ATTACHMENT 2  
PROPOSED TECHNICAL  
SPECIFICATION CHANGE  
4.5.6.2.b and BASES 3/4.5.6

### 3/4.5.6 RESIDUAL HEAT REMOVAL (RHR) SYSTEM

ATTACHMENT 3  
MARK-UP OF THE FINAL SAFETY ANALYSIS REPORT

RHR INLET ISOLATION VALVES  
 LOGIC DIAGRAM SYSTEM: RH  
 (Sheet 1 of 2)  
 Dwg. No. SR16-9-Z-42182 #1 Rev. 8  
 Figure 7.6-2 Revision 0

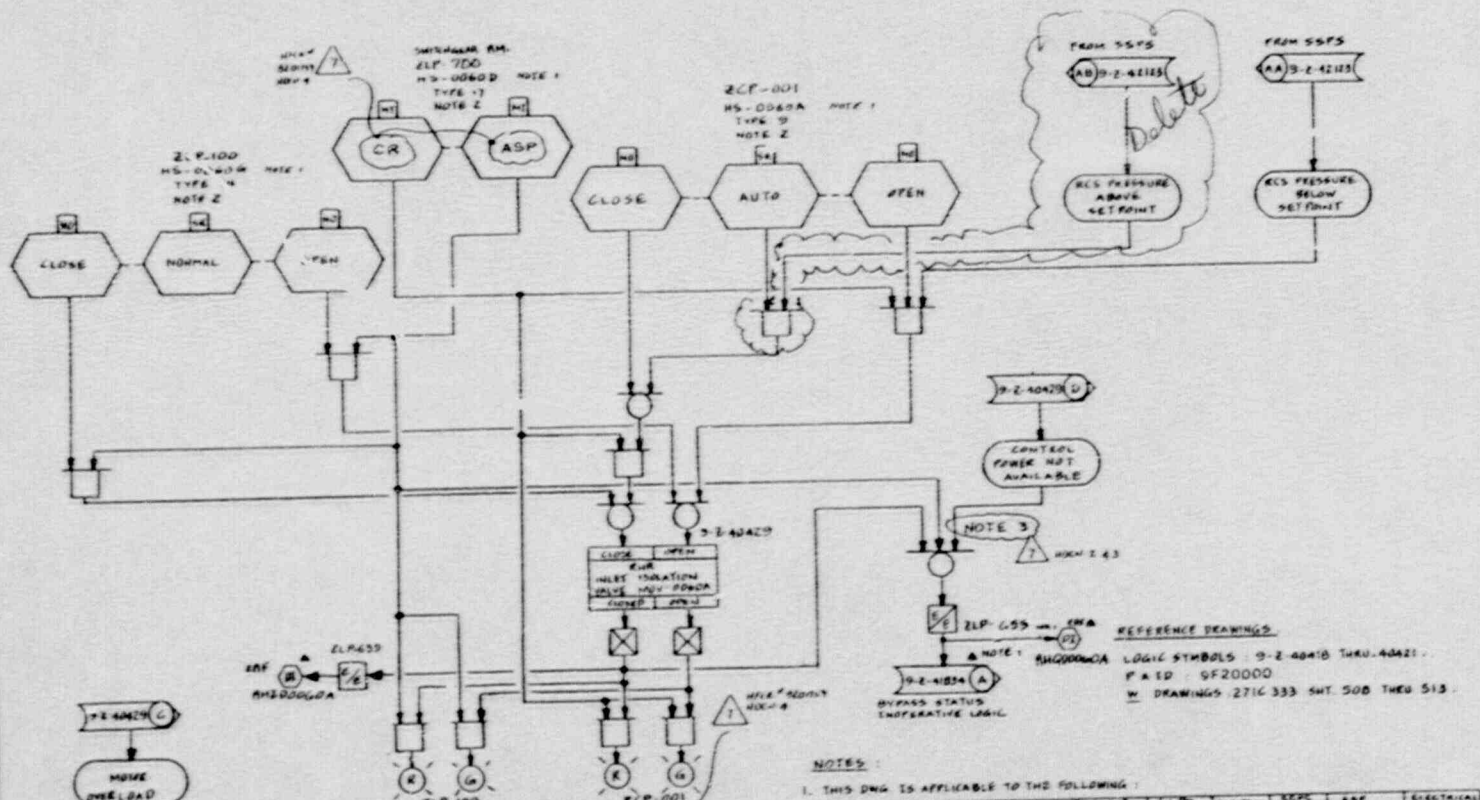
For assured plant cooldown, the protective action is the removal of the ~~automatic~~ RHRs isolation when RCS pressure is below a preset pressure. *interlock*
